Modification Instruction 3040.3100ET Level PCB CD / CCD

The pcb 3040.3100ET replaces the following spare part numbers:

CD6 - CD20 up to 9512
CM6 - CM20 up to 9104

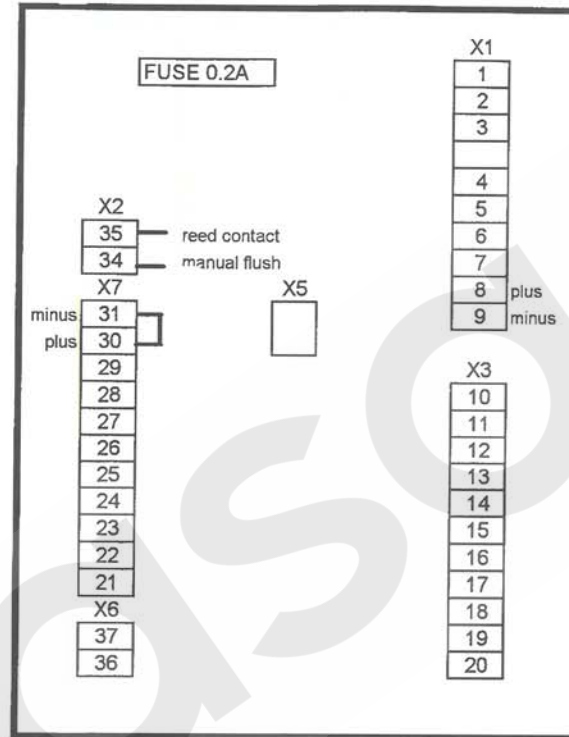
3002.0400, 3002.0408, 3040.2060, 3040.2061

CD6 - CD202 from 9706 only

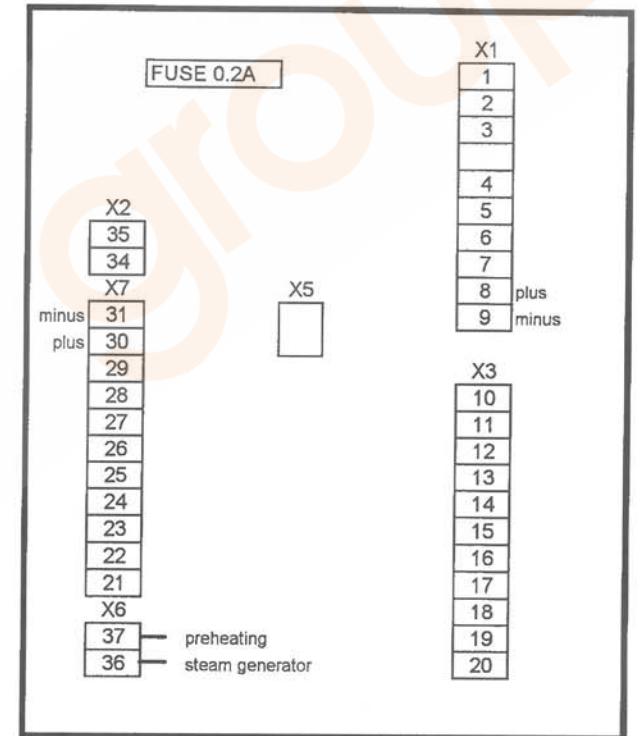
Please observe Thermocouple polarity:

Colour Code green / white:	green - plus white - minus
Colour Code red / green	red - plus green - minus

Please note: With jumper X5 in place, the SC pump will operate continuously
With jumper X5 removed, the SC pump will operate in a pulsing mode
